Prescriptive Portal Frame at Townhouse One-Hour Walls

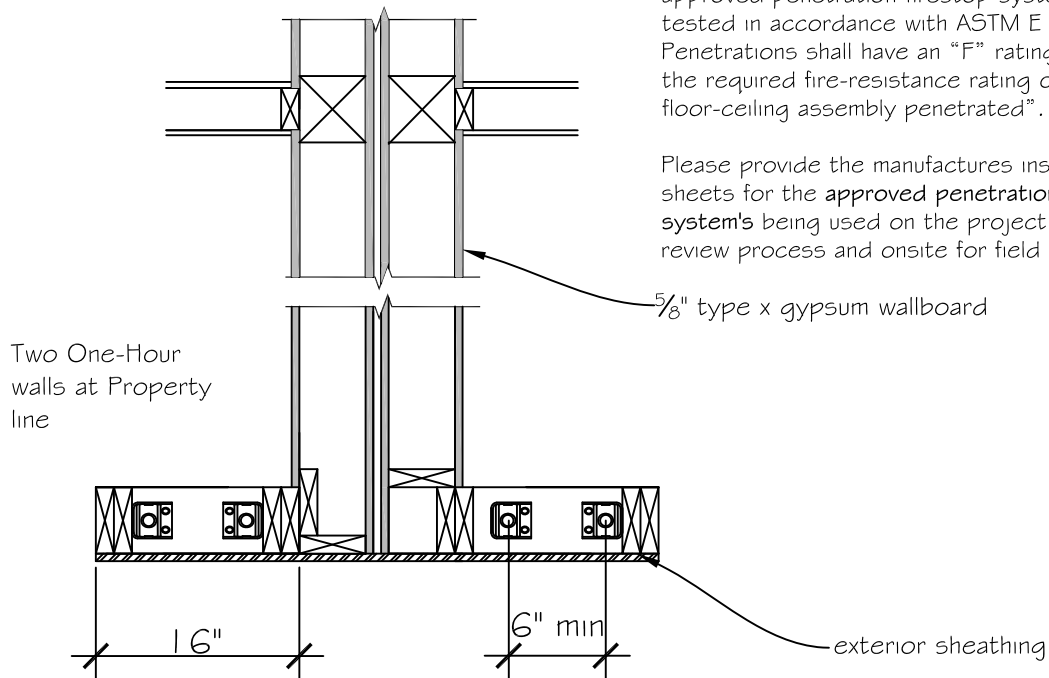
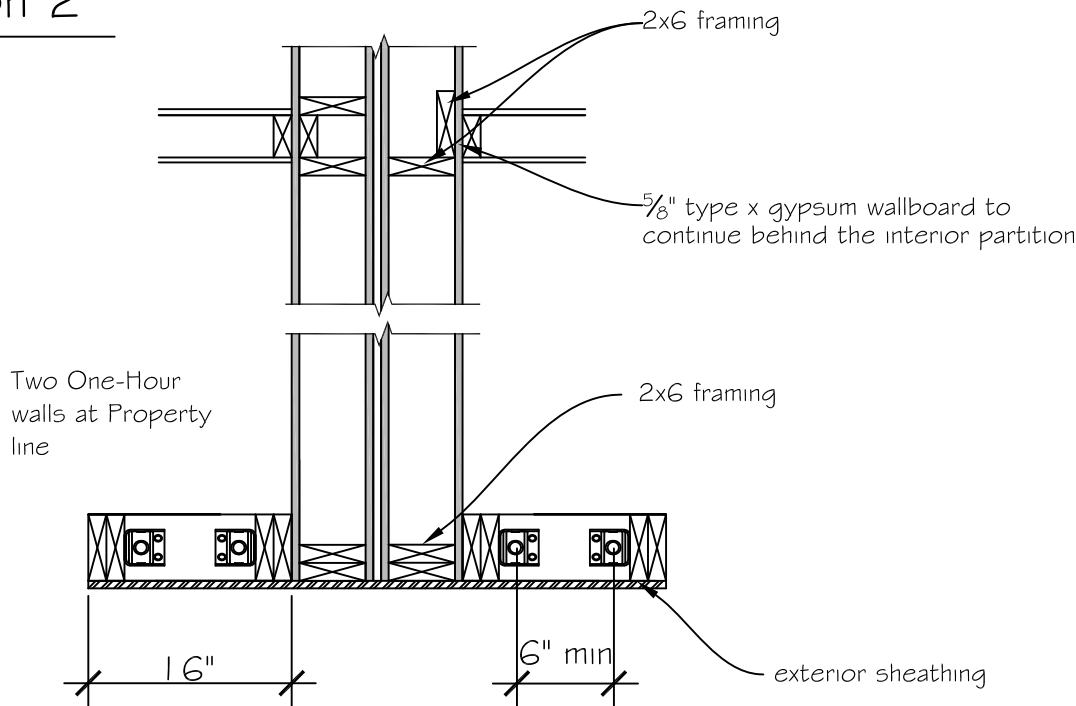
"Through penetrations shall be protected by an approved penetration firestop system installed as tested in accordance with ASTM E 814 or UL 1479. Penetrations shall have an "F" rating of not less than the required fire-resistance rating of the wall or floor-ceiling assembly penetrated".

Please provide the manufactures installation spec sheets for the approved penetration firestop system's being used on the project for both the plan review process and onsite for field inspections.
